Answers to Committee's Questions for the Q/A Session

LArASIC Production Readiness Review
7-8 March 2022

Figure 3 Plug or Unplug FE short board

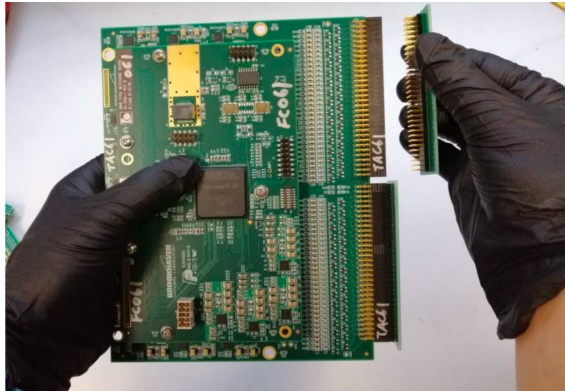
2. Plug IO-1754-1 board into connector SSW-132-21-G-T before installing them

Keep IO-1754-1 boards always in SSW-132, don't remove them.

Figure 2 How to handle FEMB

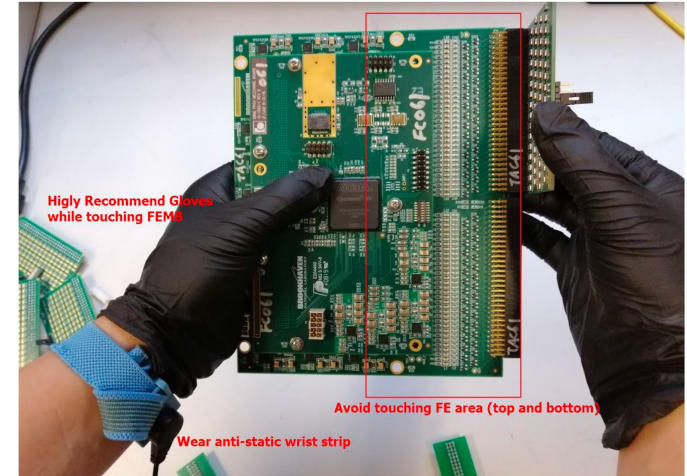
It is suggested to avoid touching FE-ASIC chips, try to hold the board as shown in picture below.

Figure 4 Avoid touching FE area (both top and bottom)

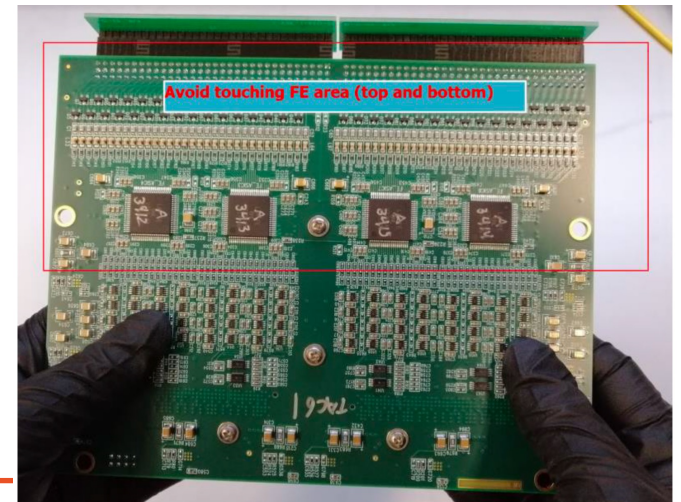
1. **ESD Protection Warning:** Please make sure you wear anti-static wrist strip while touching any boards.
2. Measure PS output, make sure it output 12V current, set current limit to 5A.
9. Add a FEMB to WIB
 - a. **Wear Anti-static wrist strip**, please avoid touch FE area if you are not wearing the gloves (sweat may contaminate FE chips)
 - c. Plug FE input short boards from the FEMB
 - d. **Put FEMB into the anti-static bag and then the bubble bag**
11. Turn PS off when you finish or before you leave, don't leave WIB on when there is no one present.
